Exhibit J

SUBJECT: Public Works Conditions of Approval
T-6366 / P22-03194 and **PUD: P22-04877**, a 71-lot private unit development
2920 North Fowler Avenue
Granville / Giannetta

SUBJECT: Conditions of Approval for **P22-04877**

SUBJECT: PUBLIC WORKS CONDITIONS OF APPROVAL FOR VESTING TENTATIVE TRACT MAP NO. 6366 REGARDING SERVICE REQUIREMENTS (P22-03194)

P22-04877
2920 N FOWLER
SITE PLAN
APN 574-120-30
TRACT 6366
2920 NORTH FOWLER AVENUE
GROSS AREA = 8.46 ACRES
NET AREA = 7.94 ACRES
DENSITY = 8.39 UNITS/ACRE
GARY G. GIANNETTA
CIVIL ENGINEERING & LAND SURVEYING
1110 1/2 STREET
FRESNO, CA 93721
(559) 264-3590

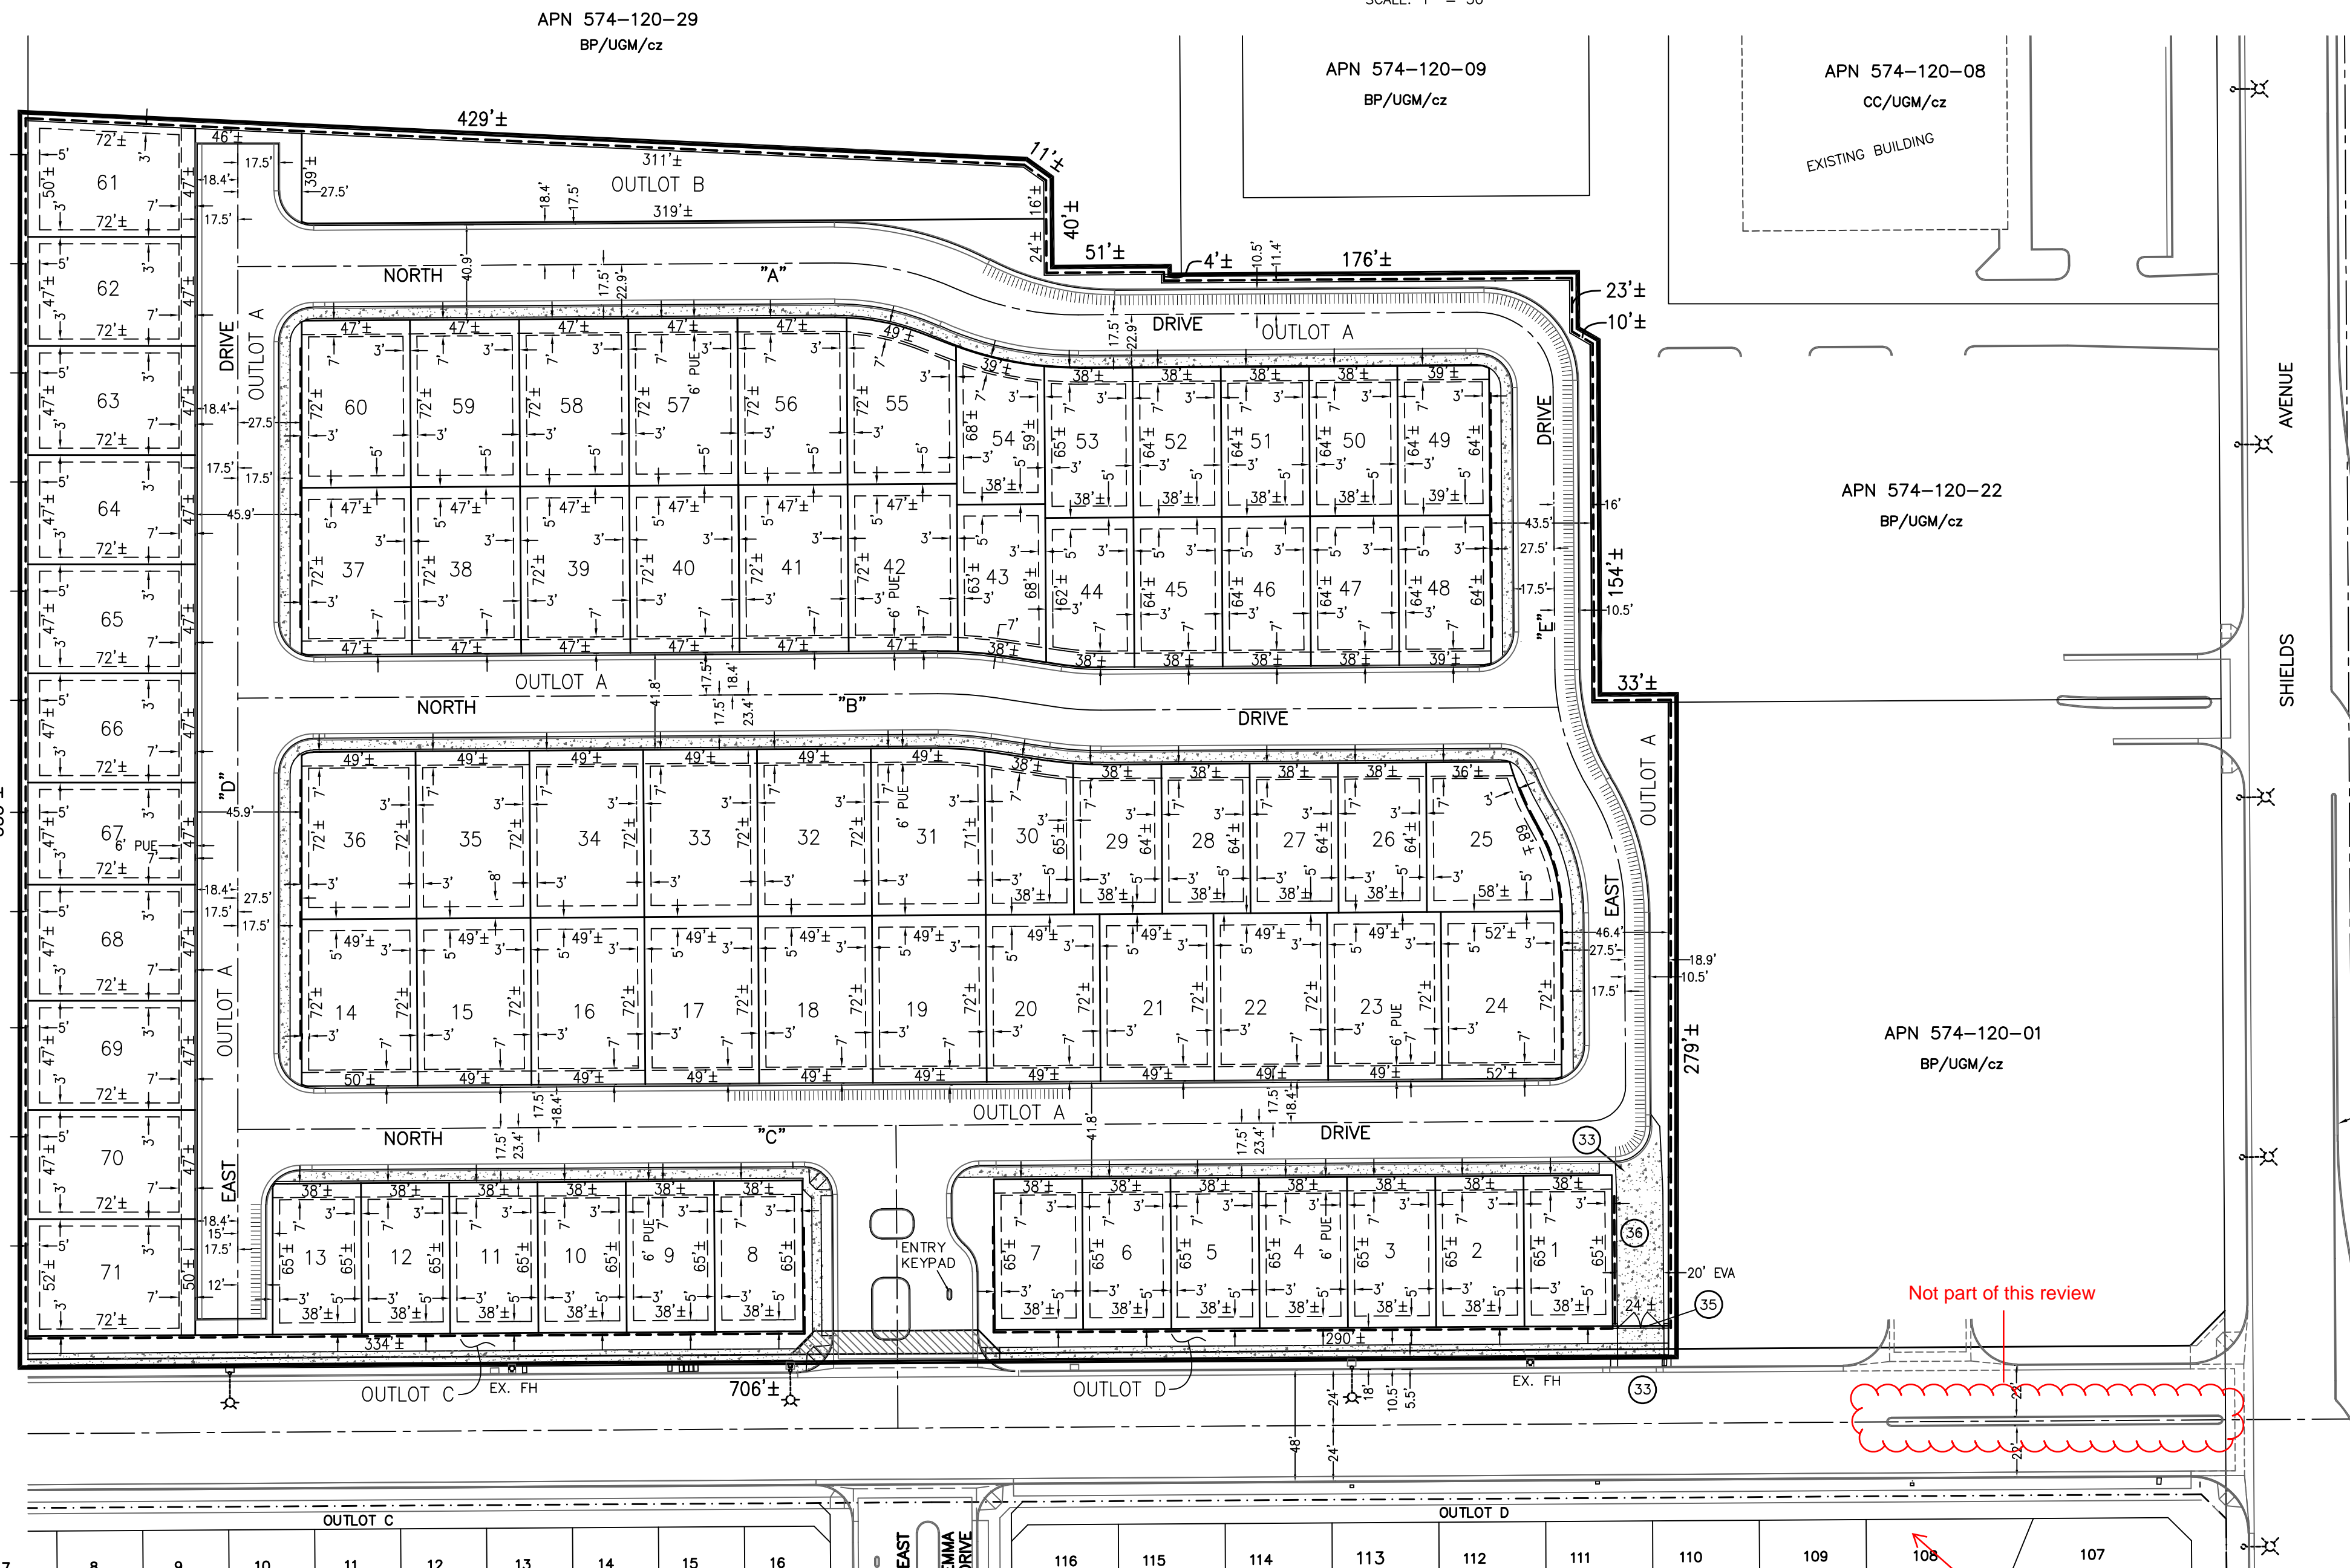
- Bridge required prior to building permits Fowler/Mill Ditch (McKinley)
- Identify Outlots.
- If PE, LE and PUE are being dedicated with Tract Map 6366, please call out/reference.
